County of Fresno

North Annex Jail ADA Transition Plan

LARS ANDERSEN & ASSOCIATES, INC.

JUNE 30, 2014

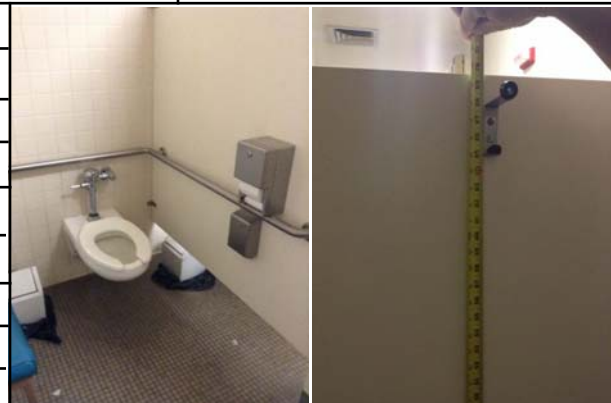
59	North Annex Jail	Priority:	3
Category		Accessories	
Issue		Recommendation	
Coat hook measured over 48" AFF		Reset hook to maximum 48" AFF	
ADA Reference:			
603.4			
CBC Reference:			
11B-603.4			
Floor:	1st		
Room:	Locker room -		
Location:	Restroom		
Cost:	100		
Duration:	1 hr

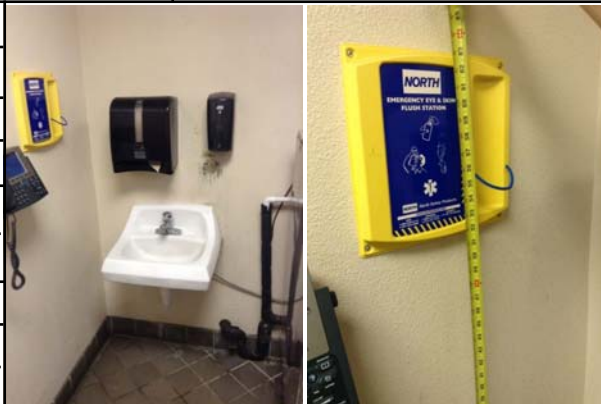
64	North Annex Jail	Priority:	3
Category		Accessories	
Issue		Recommendation	
Coat hook measured over 48" AFF		Reset hook to maximum 48" AFF	
ADA Reference:			
603.4			
CBC Reference:			
11B-603.4			
Floor:	1st		
Room:	Locker room -		
Location:	Restroom		
Cost:	100		
Duration:	1 hr

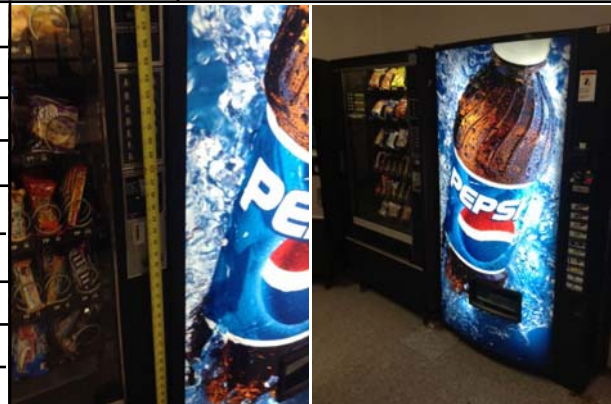
77	North Annex Jail	Priority:	2
Category		Reach Range	
Issue		Recommendation	
Maximum 46" AFF side obstructed reach range exceeded when obstruction depth is between 10"-24" & 34" max height		Provide required reach range	
ADA Reference:			
308.3.2			
CBC Reference:			
11B-308.3.2			
Floor:	1st		
Room:	Dining area		
Location:	Outdoor		
Cost:	See *8		
Duration:	See *8

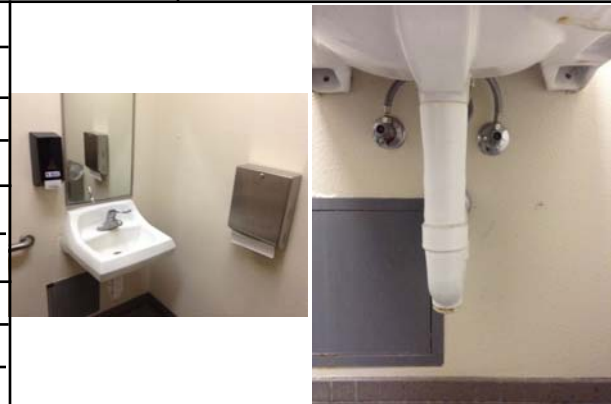
85	North Annex Jail	Priority:	1
Category		Interior Signage	
Issue		Recommendation	
Wall sign not 48" min. AFF to baseline of Braille Cells		Reset sign per current standards	
ADA Reference:			
703.4.1			
CBC Reference:			
11B-703.4.1			
Floor:	1st		
Room:	Dining area		
Location:			
Cost:	See *1		
Duration:	See *1

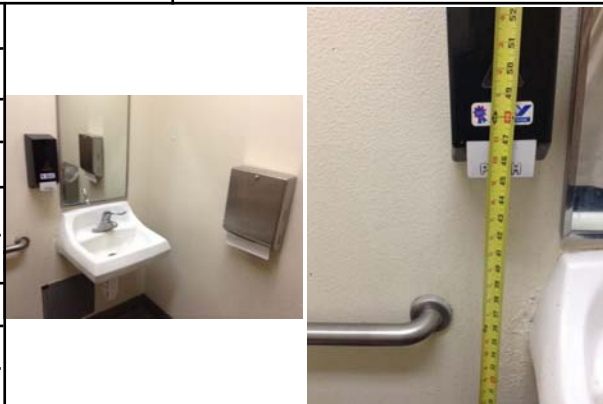
86	North Annex Jail	Priority:	3
Category		Lavatories (GENERAL)	
Issue		Recommendation	
Drain and/or hot water piping not insulated (wrapped)		Insulate as required to protect against contact	
ADA Reference:			
606.5			
CBC Reference:			
11B-606.5			
Floor:	1st		
Room:	Dining area		
Location:			
Cost:	50		
Duration:	.25 hrs

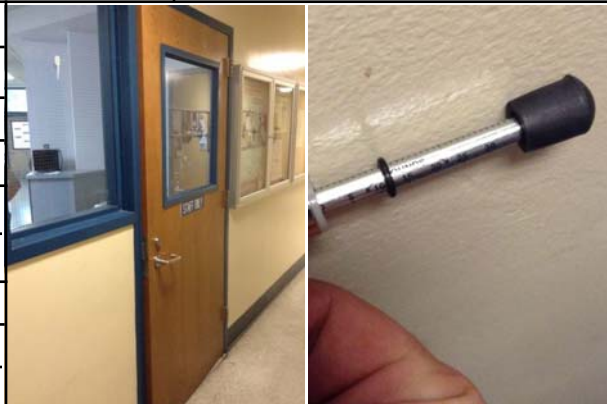
89	North Annex Jail	Priority:	3
Category		Water Closets (GENERAL)	
Issue		Recommendation	
Sidewall grab bar minimum extension 54" from rear wall		Adjust as required and/or provide new bar per current standards	
ADA Reference:			
604.5.1			
CBC Reference:			
11B-604.5.1			
Floor:	1st		
Room:	Dining area		
Location:	Restroom		
Cost:	300		
Duration:	1.5 hrs

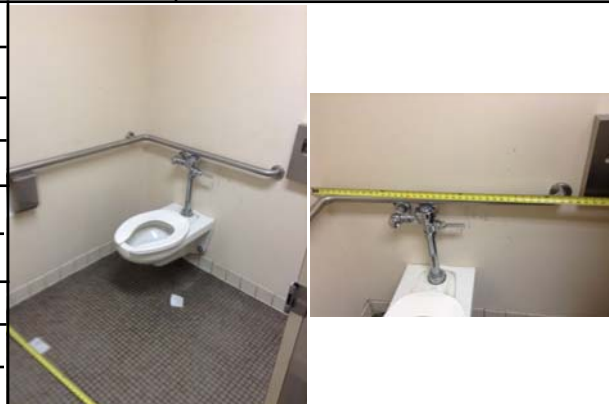
113	North Annex Jail	Priority:	3
Category		Accessories	
Issue		Recommendation	
Mirror over lavatory or countertop measured over 40" AFF to the bottom edge of the reflecting surface		Reset mirror to maximum 40" AFF to reflecting surface	
ADA Reference:			
603.3			
CBC Reference:			
11B-603.3			
Floor:	1st		
Room:	Main Entrance		
Location:	Restroom - Men		
Cost:	100		
Duration:	1 hr

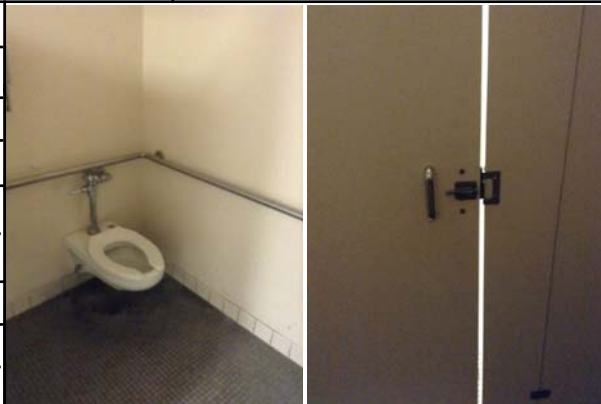
132	North Annex Jail	Priority:	3
Category		Water Closet Compartments (GENERAL)	
Issue		Recommendation	
Door encroaches more than 12" into required turning space		Adjust door swing	
ADA Reference:			
N/A			
CBC Reference:			
11B-603.2.3			
Floor:	1st		
Room:	Main Entrance		
Location:	Restroom -		
Cost:	4000		
Duration:	20 hrs

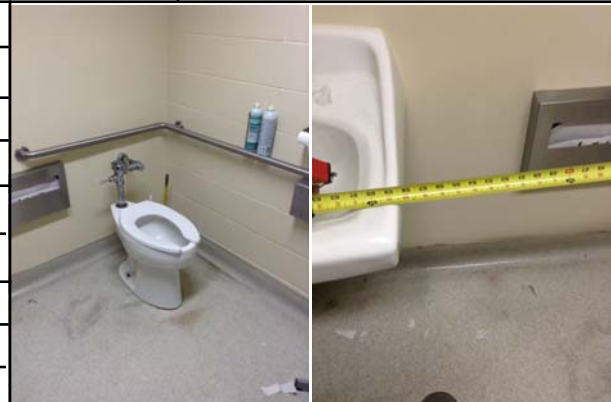
141	North Annex Jail	Priority:	1
Category		Doors / Gates	
Issue		Recommendation	
Door requires over 5 lbs force to open		Adjust closing device	
ADA Reference:			
404.2.9			
CBC Reference:			
11B-404.2.9			
Floor:	2nd		
Room:	Staff Restroom		
Location:			
Cost:	See *2		
Duration:	See *2

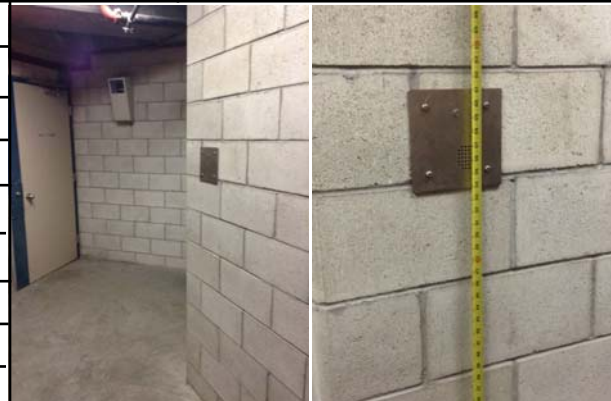
155	North Annex Jail	Priority:	4
Category		Alarms	
Issue		Recommendation	
Audible Fire Alarm not provided in public or common use areas		Provide audible and visual fire alarm per current standards	
ADA Reference:			
215.2			
CBC Reference:			
11B-215.2			
Floor:	2nd		
Room:	Corridor		
Location:			
Cost:	See *4		
Duration:	See *4

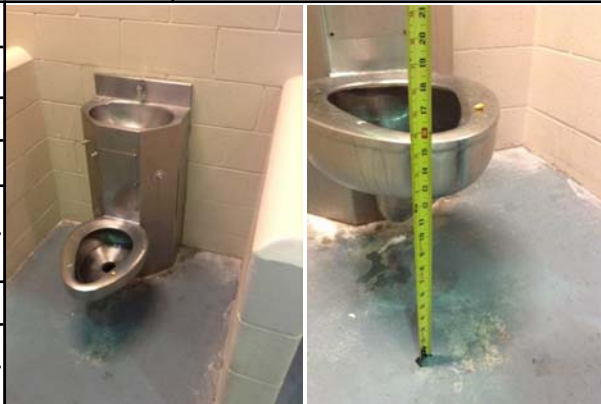
164	North Annex Jail	Priority:	2
Category		Detention Facility Water Closets (GENERAL)	
Issue		Recommendation	
Water Closet not accessible		Provide accessible water closet	
ADA Reference:			
604.1			
CBC Reference:			
11B-604.1			
Floor:	2nd		
Room:	Gym		
Location:	Restroom		
Cost:	4000		
Duration:	20 hrs

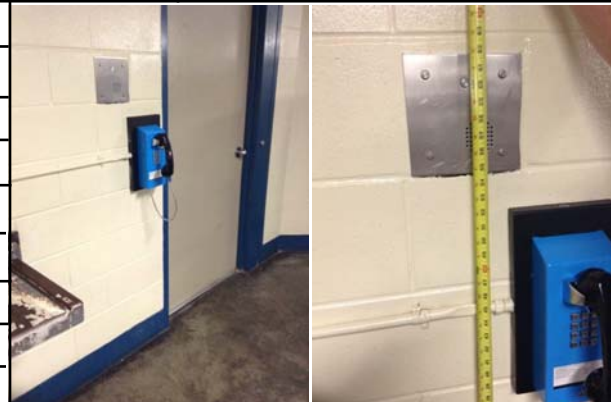
179	North Annex Jail	Priority:	2
Category		Reach Range	
Issue		Recommendation	
Maximum 48" AFF reach range exceeded /(forward unobstructed reach, 10" maximum reach depth)		Provide required reach range	
ADA Reference:			
308.2.1			
CBC Reference:			
11B-308.2.1			
Floor:	2nd		
Room:	Classroom		
Location:			
Cost:	See *7		
Duration:	See *7

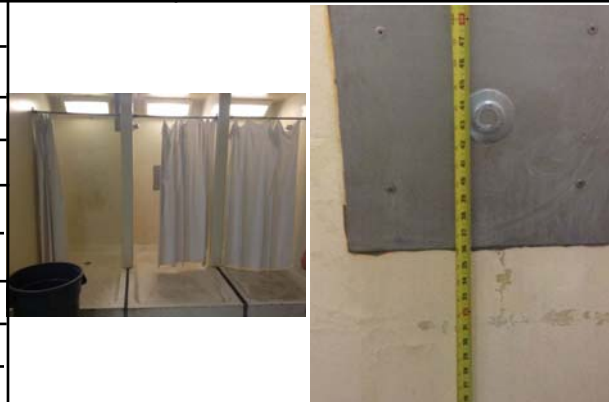
221	North Annex Jail	Priority:	2
Category		Detention Facility Showers	
Issue		Recommendation	
Shower floor slope greater than 2.083 percent		Provide accessible shower	
ADA Reference:			
N/A			
CBC Reference:			
11B-608.9			
Floor:	2nd		
Room:	Pod-B		
Location:	Upstairs		
Cost:	See *6		
Duration:	See *6

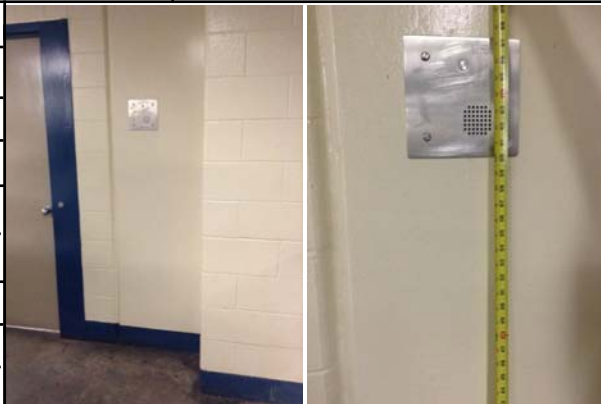
226	North Annex Jail	Priority:	2
Category		Detention Facility Showers	
Issue		Recommendation	
Centerline of water control not 39"-41" above shower floor and top of unit not greater than 48"		Adjust as required	
ADA Reference:			
N/A			
CBC Reference:			
11B-608.5.2			
Floor:	2nd		
Room:	Pod-B		
Location:	Upstairs		
Cost:	See *6		
Duration:	See *6

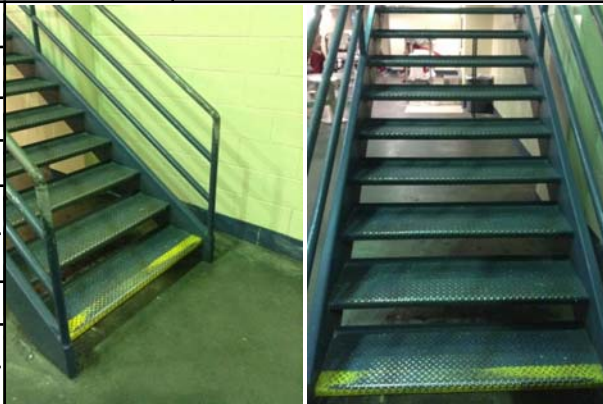
230	North Annex Jail	Priority:	4
Category		Drinking Fountains	
Issue		Recommendation	
50% of all drinking fountains are not wheel chair accessible		Install wheel chair accessible drinking fountain(s)	
ADA Reference:			
211.3			
CBC Reference:			
11B-211.3			
Floor:	2nd		
Room:	Pod-C		
Location:			
Cost:	See *6		
Duration:	See *6

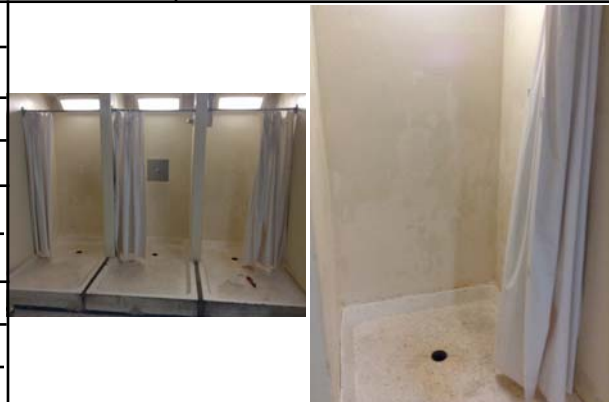
244	North Annex Jail	Priority:	2
Category		Detention Facility Water Closets (GENERAL)	
Issue		Recommendation	
Grab bars not provided on rear wall		Provide required grab bar	
ADA Reference:			
604.5			
CBC Reference:			
11B-604.5			
Floor:	2nd		
Room:	Pod-C		
Location:	Upstairs		
Cost:	See *6		
Duration:	See *6

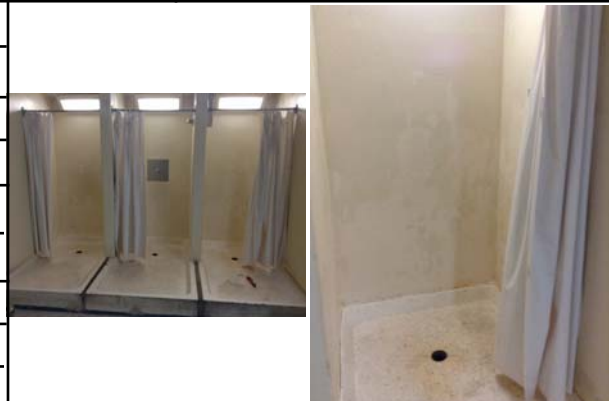
246	North Annex Jail	Priority:	1
Category		Walks	
Issue		Recommendation	
Cross slope of walk over 2.083% (1:48)		Provide concrete walk with maximum 2.0% slope cross slope where cross slope exceeds 2.0%	
ADA Reference:			
403.3			
CBC Reference:			
11B-403.3			
Floor:	2nd		
Room:	Pod-C		
Location:	Upstairs		
Cost:	See *6		
Duration:	See *6

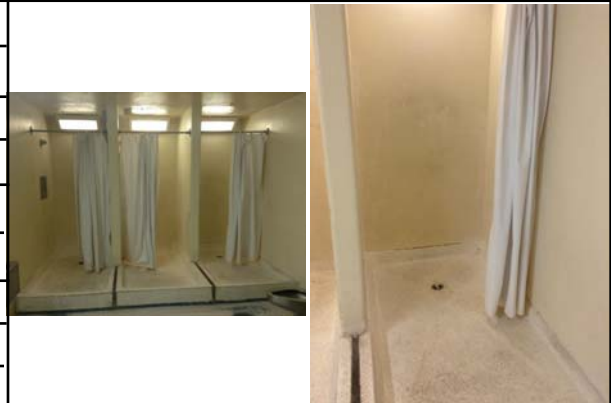
273	North Annex Jail	Priority:	2
Category		Detention Facility Water Closets (GENERAL)	
Issue		Recommendation	
Grab bars not provided on sidewall		Provide required grab bar	
ADA Reference:			
604.5			
CBC Reference:			
11B-604.5			
Floor:	2nd		
Room:	Pod-D		
Location:	Upstairs		
Cost:	See *6		
Duration:	See *6

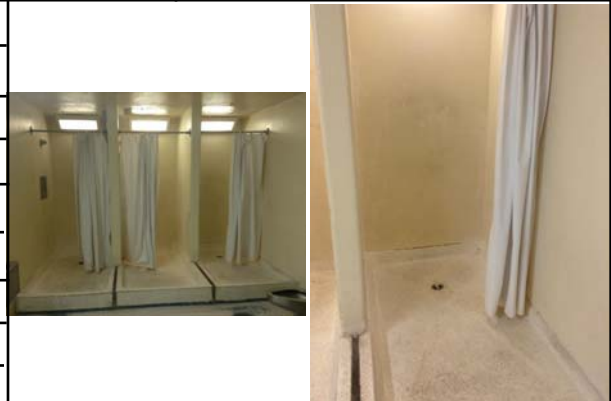
275	North Annex Jail	Priority:	1
Category		Walks	
Issue		Recommendation	
Cross slope of walk over 2.083% (1:48)		Provide concrete walk with maximum 2.0% slope cross slope where cross slope exceeds 2.0%	
ADA Reference:		 	
403.3			
CBC Reference:			
11B-403.3			
Floor:	2nd		
Room:	Pod-D		
Location:	Upstairs		
Cost:	See *6		
Duration:	See *6

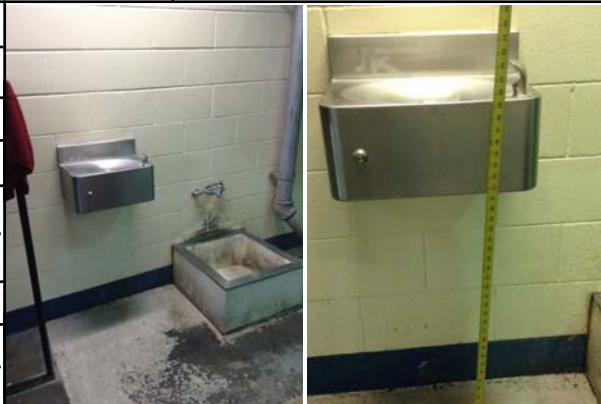
280	North Annex Jail	Priority:	2
Category		Detention Facility Showers	
Issue		Recommendation	
Grab bar not provided on side wall opposite of seat in standard shower		Provide new bar per current standards	
ADA Reference:			
608.3.2			
CBC Reference:			
11B-608.3.2			
Floor:	2nd		
Room:	Pod-D		
Location:	Upstairs		
Cost:	See *6		
Duration:	See *6

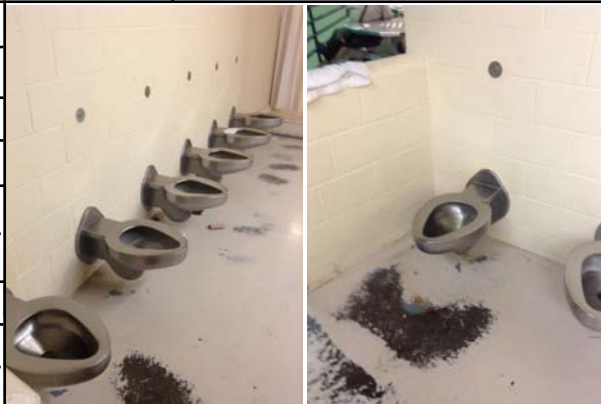
293	North Annex Jail	Priority:	2
Category		Dining/Bar Facilities	
Issue		Recommendation	
Required 30" by 48" clear floor space not provided at accessible seating spaces		Provide required clear floor space at accessible seating	
ADA Reference:			
902.2			
CBC Reference:			
11B-902.2			
Floor:	2nd		
Room:	Pod-E		
Location:	Upstairs		
Cost:	See *6		
Duration:	See *6

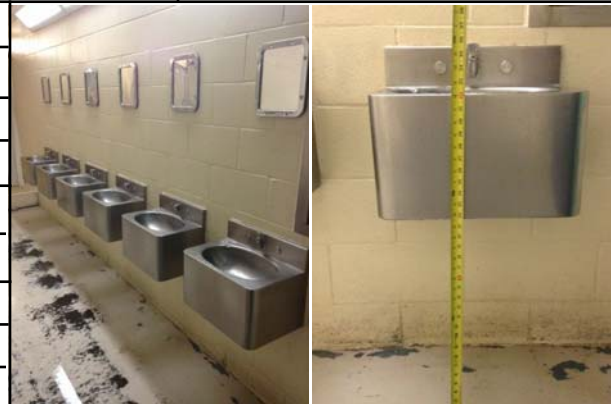
294	North Annex Jail	Priority:	2
Category		Reach Range	
Issue		Recommendation	
Maximum 48" AFF reach range exceeded /(forward unobstructed reach, 10" maximum reach depth)		Provide required reach range	
ADA Reference:			
308.2.1			
CBC Reference:			
11B-308.2.1			
Floor:	2nd		
Room:	Pod-E		
Location:	Upstairs		
Cost:	See *7		
Duration:	See *7

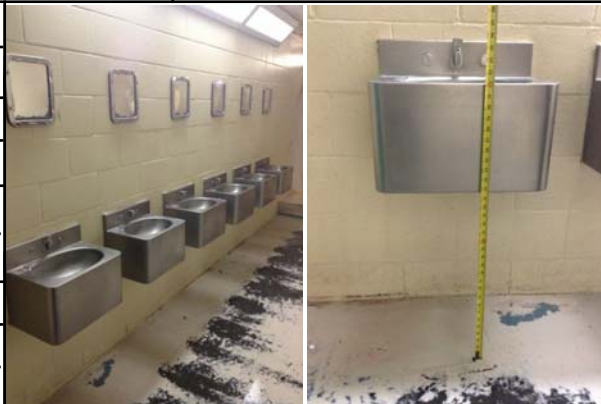
318	North Annex Jail	Priority:	1
Category		Stairs	
Issue		Recommendation	
Extension of handrail at top stairs not 12" minimum of level distance (parallel with floor) beyond top nosing		Modify handrail(s) to provide required 12" extensions or replace per current standards	
ADA Reference:			
505.10.2			
CBC Reference:			
11B-505.10.2			
Floor:	2nd		
Room:	Pod-F		
Location:			
Cost:	500		
Duration:	5 hrs

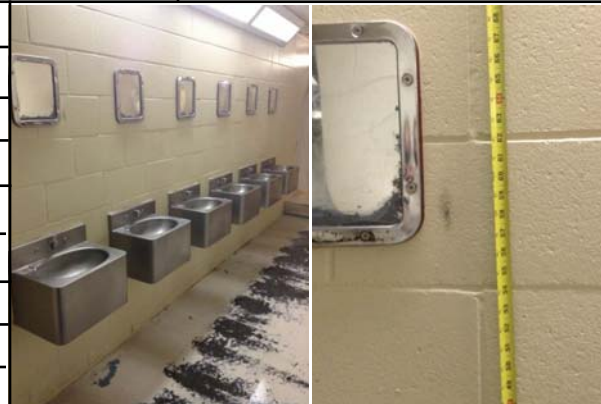
319	North Annex Jail	Priority:	2
Category		Dining/Bar Facilities	
Issue		Recommendation	
At least 5% of total seating is not accessible 24 Seats		Provide accessible seating spaces as required	
ADA Reference:			
226.1			
CBC Reference:			
11B-226.1			
Floor:	2nd		
Room:	Pod-F		
Location:			
Cost:	See *6		
Duration:	See *6

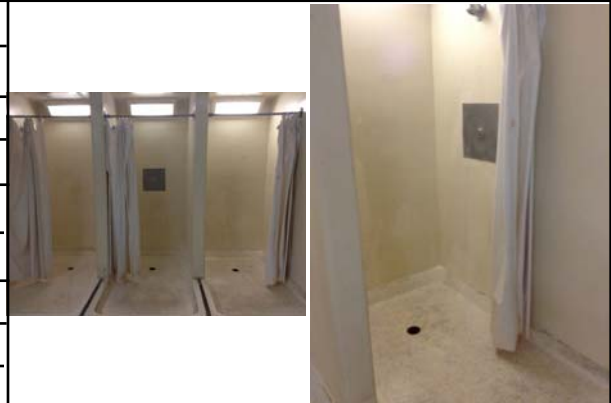
327	North Annex Jail	Priority:	2
Category		Detention Facility Water Closets (GENERAL)	
Issue		Recommendation	
Grab bars not provided on sidewall		Provide required grab bar	
ADA Reference:			
604.5			
CBC Reference:			
11B-604.5			
Floor:	2nd		
Room:	Pod-F		
Location:	Upstairs		
Cost:	See *6		
Duration:	See *6

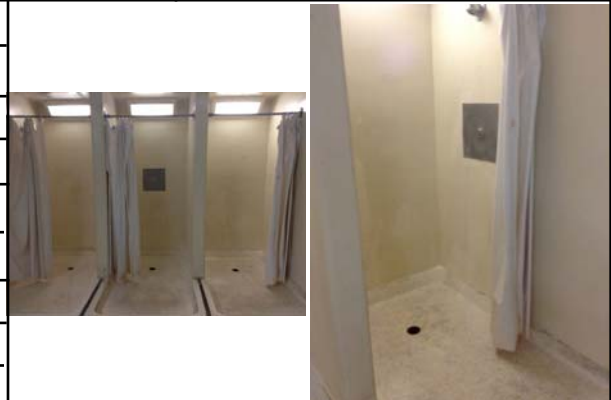
330	North Annex Jail	Priority:	2
Category		Detention Facility Showers	
Issue		Recommendation	
Centerline of water control not 39"-41" above shower floor and top of unit not greater than 48"		Adjust as required	
ADA Reference:			
N/A			
CBC Reference:			
11B-608.5.2			
Floor:	2nd		
Room:	Pod-F		
Location:	Upstairs		
Cost:	See *6		
Duration:	See *6

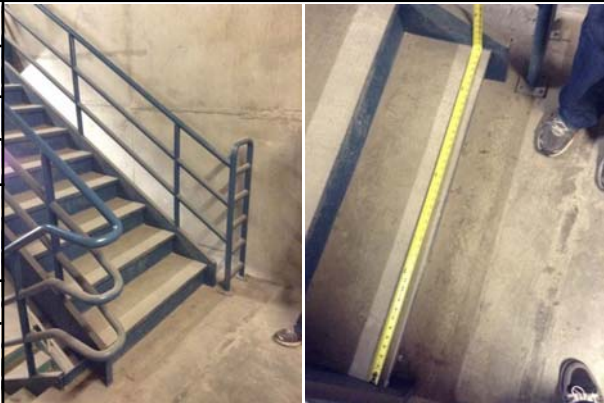
348	North Annex Jail	Priority:	3
Category		Accessories	
Issue		Recommendation	
Towel dispenser measured over 40" AFF to operable part		Reset accessories to maximum 40" AFF to operating controls	
ADA Reference:			
N/A			
CBC Reference:			
11B-603.5			
Floor:	3rd		
Room:	Infirmary		
Location:			
Cost:	See *1		
Duration:	See *1

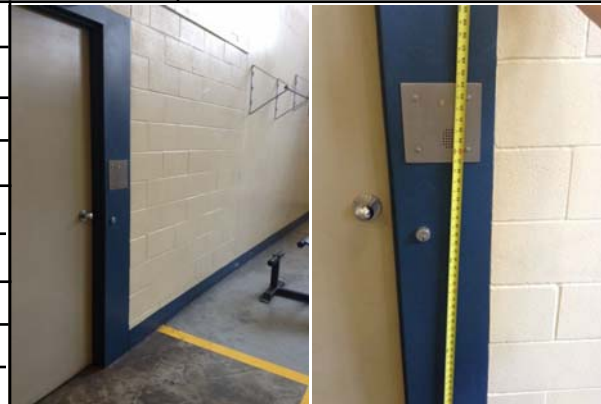
368	North Annex Jail	Priority:	2
Category		Detention Facility Water Closets (GENERAL)	
Issue		Recommendation	
Grab bars not provided on rear wall		Provide required grab bar	
ADA Reference:			
604.5			
CBC Reference:			
11B-604.5			
Floor:	3rd		
Room:	Gym		
Location:	Restroom		
Cost:	50		
Duration:	.5 hrs

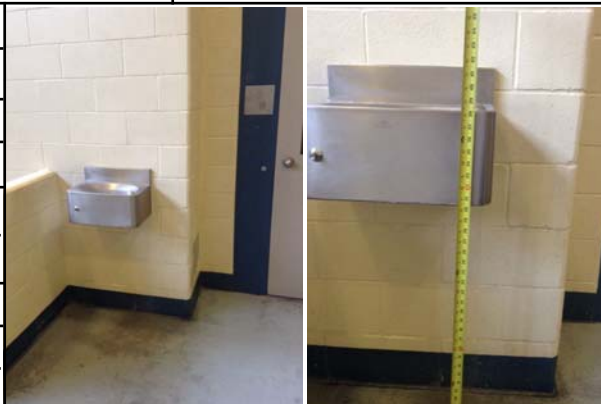
369	North Annex Jail	Priority:	2
Category		Detention Facility Water Closets (GENERAL)	
Issue		Recommendation	
Grab bars not provided on sidewall		Provide required grab bar	
ADA Reference:			
604.5			
CBC Reference:			
11B-604.5			
Floor:	3rd		
Room:	Gym		
Location:	Restroom		
Cost:	See *2		
Duration:	See *2

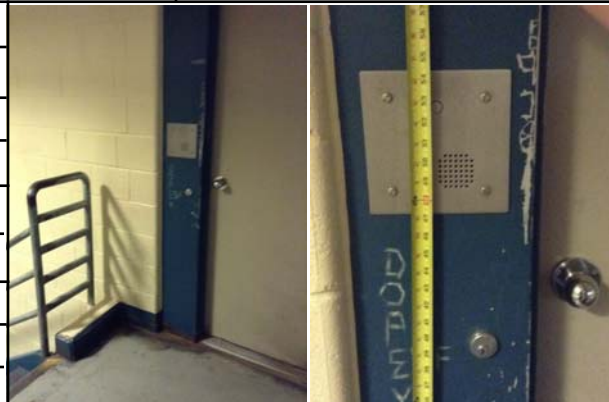
409	North Annex Jail	Priority:	4
Category		Telephones	
Issue		Recommendation	
At least one TTY not provided in a secured area of a correctional facility if a public phone for detainees is provided		Provide accessible TTY per current standards	
ADA Reference:			
217.4.2.2			
CBC Reference:			
11B-217.4.2.2			
Floor:	3rd		
Room:	Pod-B		
Location:			
Cost:	See *6		
Duration:	See *6

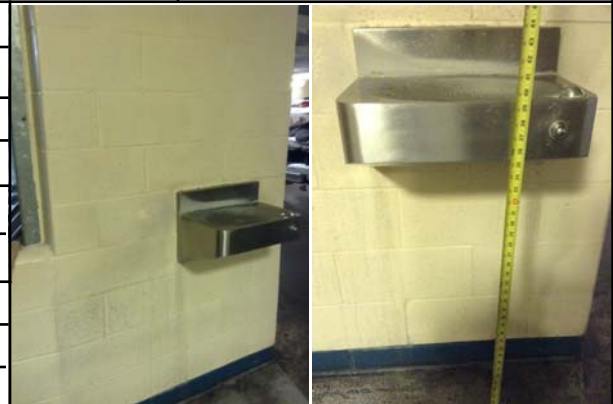
414	North Annex Jail	Priority:	1
Category		Stairs	
Issue		Recommendation	
Extension of handrail at top stairs not 12" minimum of level distance (parallel with floor) beyond top nosing		Modify handrail(s) to provide required 12" extensions or replace per current standards	
ADA Reference:			
505.10.2			
CBC Reference:			
11B-505.10.2			
Floor:	3rd		
Room:	Pod-B		
Location:	Upstairs		
Cost:	See *6		
Duration:	See *6

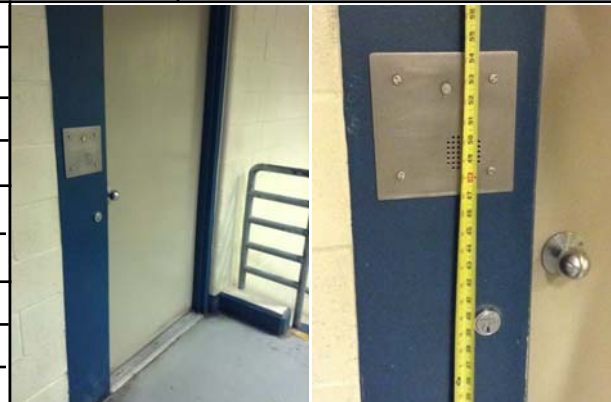
438	North Annex Jail	Priority:	4
Category		Telephones	
Issue		Recommendation	
At least one TTY not provided in a secured area of a correctional facility if a public phone for detainees is provided		Provide accessible TTY per current standards	
ADA Reference:			
217.4.2.2			
CBC Reference:			
11B-217.4.2.2			
Floor:	3rd		
Room:	Pod-C		
Location:			
Cost:	See *6		
Duration:	See *6

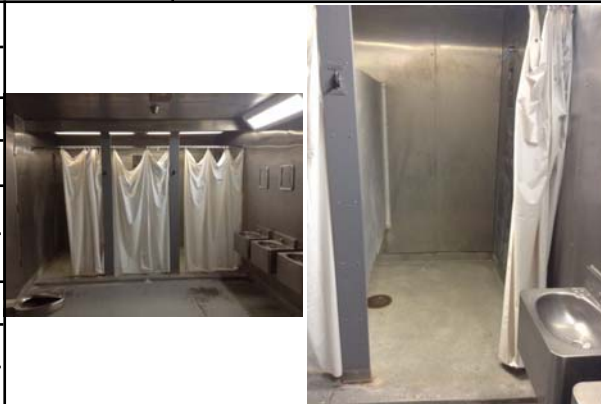
452	North Annex Jail	Priority:	2
Category		Reach Range	
Issue		Recommendation	
Maximum 48" AFF reach range exceeded /(forward unobstructed reach, 10" maximum reach depth)		Provide assistance placard	
ADA Reference:			
308.2.1			
CBC Reference:			
11B-308.2.1			
Floor:	3rd		
Room:	Pod-C		
Location:	Upstairs		
Cost:	500		
Duration:	5 hrs
